TMDXEVM6670 EVM Known issues

2. TMDXEVM6670 Production EVM Enhancements

3. TMDXEVM6670 Production EVM Issues

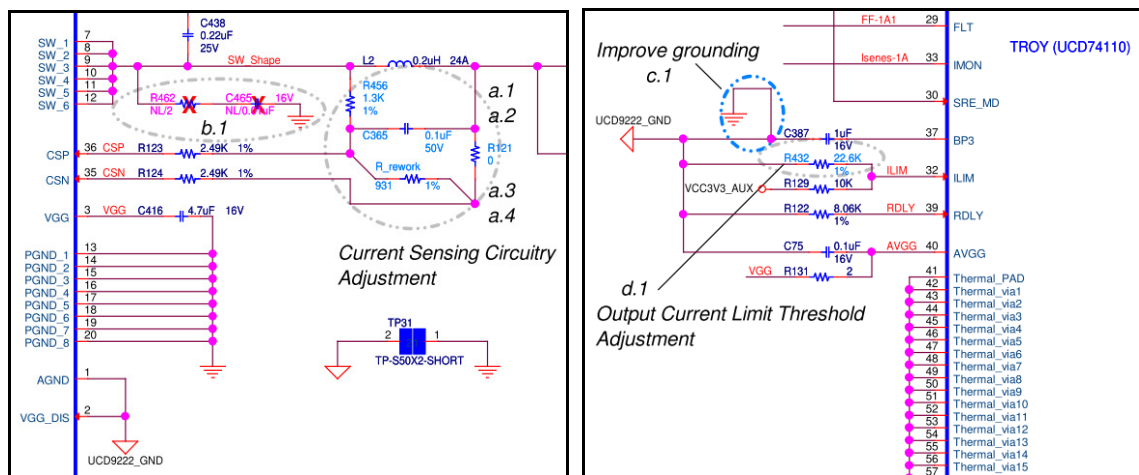
2. The current sensing circuitry on UCD74110 was changed to match the DCR of the output inductor. This was required for proper current monitoring of the UCD74110 by the UCD9222.

- a) Modify R456 to 1.3k-ohm, C365 to 0.1uF, R121 to 0-ohm, and additional 931-ohm across the ends of R123 and R124 near C365 and R121 side for the correct current sensing;
- b) Modify R432 to 22.6k-ohm for current limitation;
- c) Remove R462 and C465.

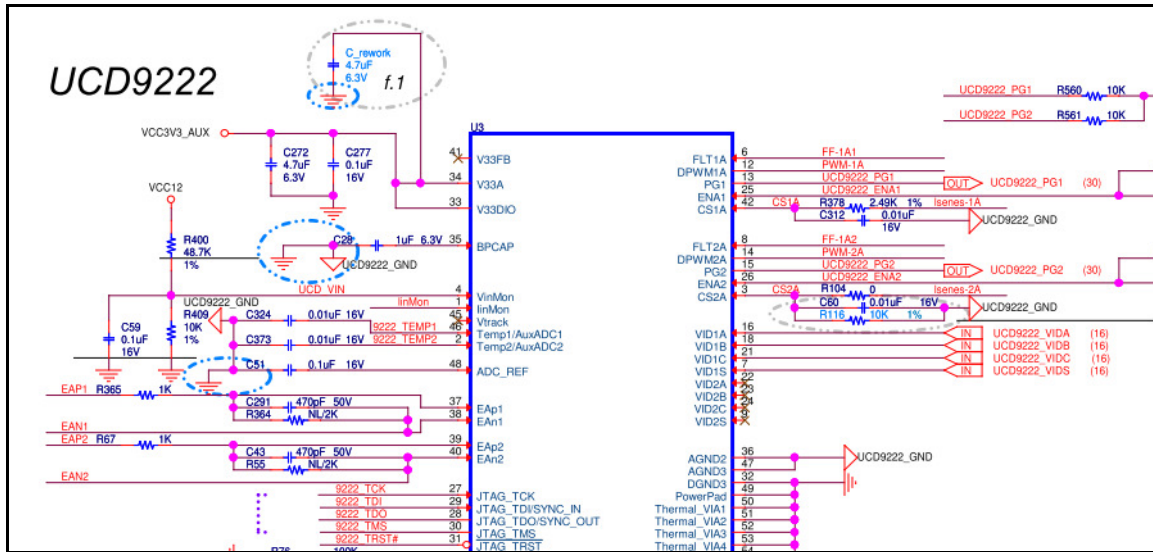
3. Correct the ISENSE resistor to allow the UCD9222 to correctly sample the current estimate from the UCD74110.

- a) Modify R116 to 10k-ohm for correct current feedback from UCD74106.

4. Improve decoupling of the V33A pin of the UCD9222. Add an additional 4.7uF capacitor across the V33A and AGND pins. Please note that the additional cap is not needed if there is a cap, such as C272 in below figure, placed on the same side with UCD9222 and adjacent the V33A and AGND pins of UCD9222.

3.2 CDCE62002 PLL locking issue on the EVM

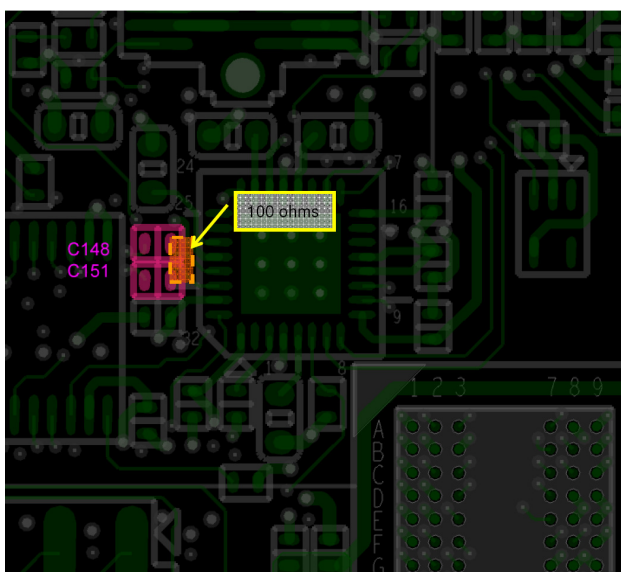
The C6670 Rev2.0 production EVMs require a termination resistor across the reference clock input of the CDCE62002. Lack of the termination allowed noise to be coupled onto the differential clock signal which prevented the PLL from locking robustly. This LVPECL clock signal should have a 100-ohm termination but it was omitted in the design.

The ECN is adding a 100-ohm resistor across the ends of C148 and C151 nearby the input of CDCE62002 to reduce the noise. It makes the output clock stable and PLL robustly locked.

4.2 HyperLink timing synchronization:

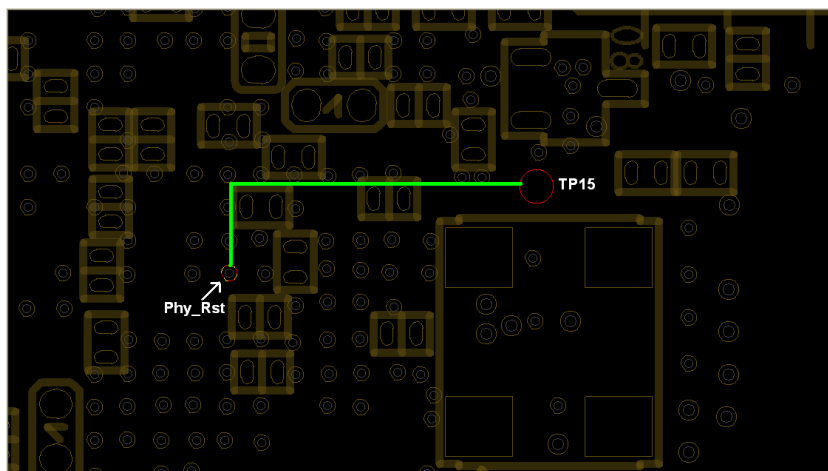
- a) The SYNC pin on CDCE62005 of CLK#2 connects to 80-pin expansion header to synchronize the MCMCLK outputs between two EVM boards for common timing;
- b) The TCLKB LVDS clock from the AMC edge connector is driven into the CLK#2 PRIREF input to provide the common reference timing for the MCMCLK clocks between two EVM boards.

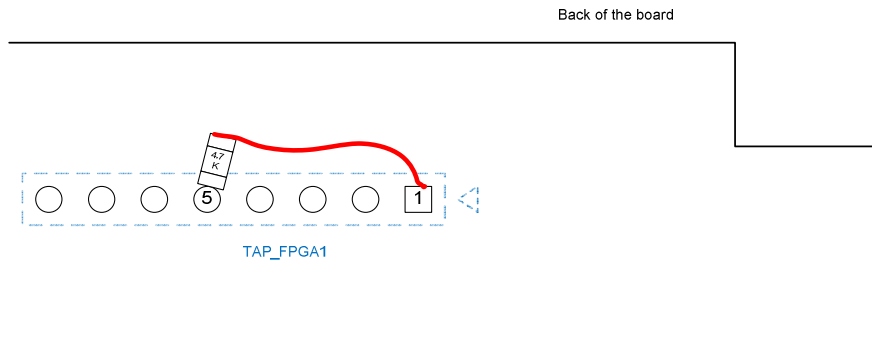
The Beta1 and Beta2 EVMs of C6670 were corrected before shipment. The RESET# (PHY_RST#) signal of 88E1111, the PHY of Gigabit Ethernet, was driven by an input pin K11 of FPGA instead output, it makes the PHY stay in reset state. The workaround is connecting the PHY_RST# to the TP15 pad of FPGA to fix the problem. The below figure shows the rework done on the PCB backside of Beta1 and Beta2 EVMs.

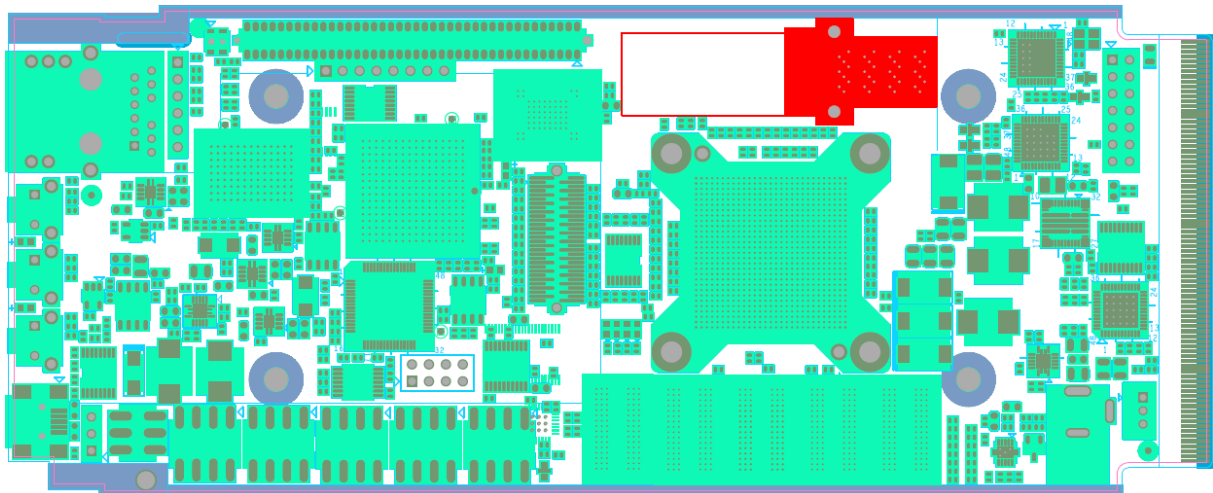
All Beta1 and Beta2 EVMs have a design erratum that may need to be corrected. Beta2 EVMs received this ECN before they were shipped from the factory. The TDI input to the FPGA is floating. This has been observed to allow unexpected FPGA behavior on a small percentage of the boards. Often the SYSPG_D1 LED goes out and CCS unexpectedly disconnects. A pull-up resistor needs to be added to prevent this from happening. This can be added on the bottom of connector TAP_FPGA1 between pins 1 and 5. Any resistor value between 1K and 10K will suffice. The following figure shows this rework.
